Thor Motor Coach Technical Service Bulletin

TSB #	TSB 20-08		
Description/Title:	Overhead Cabinets		
Affected Product Line(s):	<i>Certain model year</i> 2014, 2016-2017 Tuscany XTE 2016-2017 Tuscany 2016 Venetian 2016-2020 ACE, Miramar, Outlaw, Palazzo, 2016-2018 Hurricane, Windsport		
Service Campaign # :	RC000209	Released Date:	1/13/2021
Codes:	Inspect Only: TMCTS80263Y Inspect with Repair: TMCTS80263W	Document Date:	1/13/2021
Time Allowed:	Inspect Only: 0.2 Inspect with Repair: 0.3	Document Revision:	A

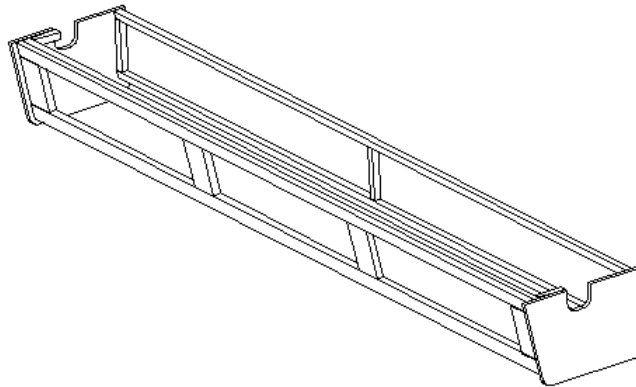
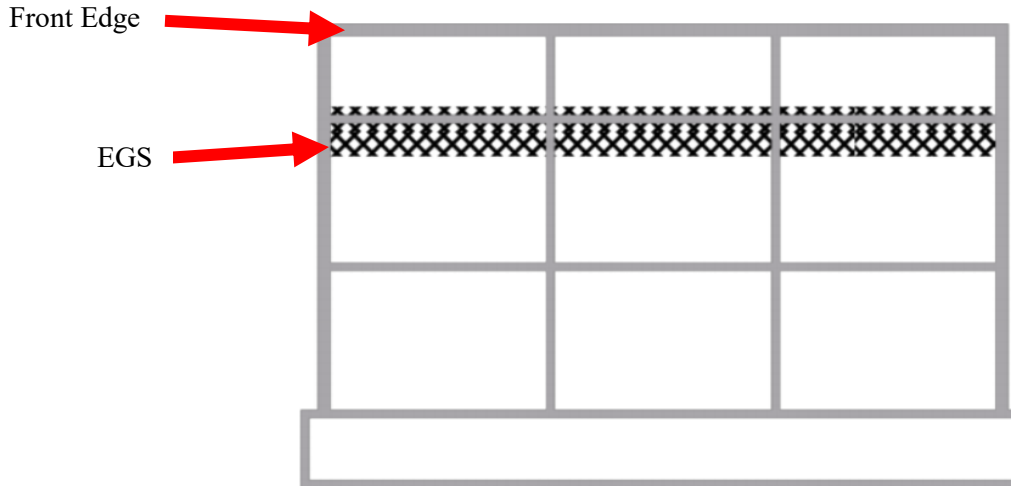
The overhead cabinets located above the driver and front passenger seats may become loose during travel. This Technical Service Bulletin will be gathering information regarding this possible concern and will provide guidance on how to ensure the overhead cabinets are properly secured in the motorhome.

1. Verify that the rear of the cabinet is mounted all the way to the front edge of the bed deck. The rear stile of the cabinet will be screwed into the aluminum tube of the bed deck. (The aluminum tube is not visible on finished product.) This will line up the front edge of the cabinet to be screwed into the area of the EGS backer (EGS is not visible on finished product).

2. The screws into the front and rear stiles should be spaced at minimum every **six (6)** inches. If they are not, add additional screws as needed.
3. If further repairs are needed, please contact TMC directly at (877) 500-1020 for additional assistance.
